COMMUNITY BOARD FEEDBACK PACKAGE

DINING OUT NYC

Business Name: Alfie's

Cafe Location: 800 9 AVENUE, NEW YORK, NY, 10019

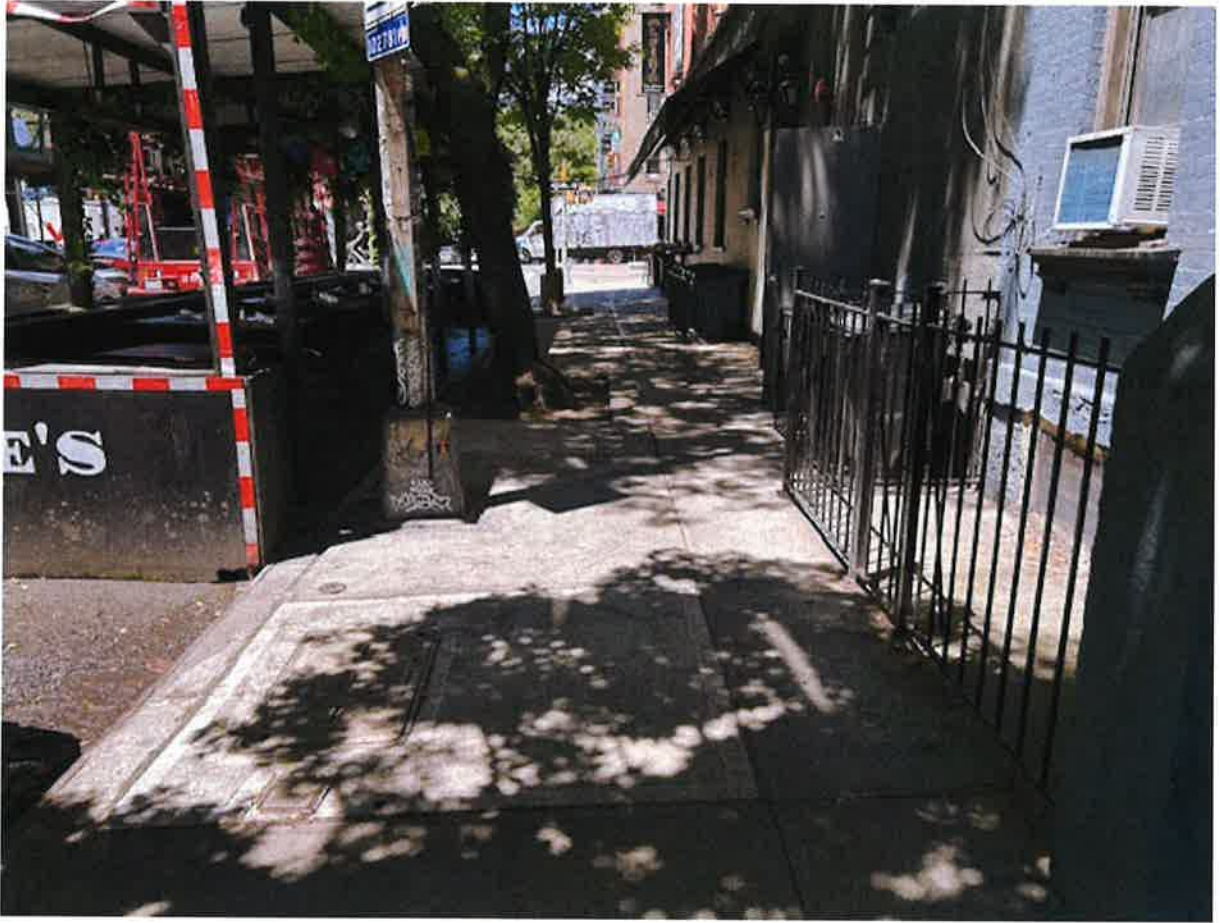
The original Site Plan for the roadway cafe did not allow sufficient space for the cafe tables to be served from within the cafe perimeter

MCB4 recommends removing sufficient tables and chairs from the roadway cafe to allow for service from within the roadway cafe perimeter.

To allow for service from within the roadway cafe perimeter, MCB4 suggests that 2 tables with 2 seats each be removed from the roadway cafe. The applicant has agreed to this change and prepared the attached Revised Site Plan reducing the roadway cafe to 7 tables with 2 seats each.
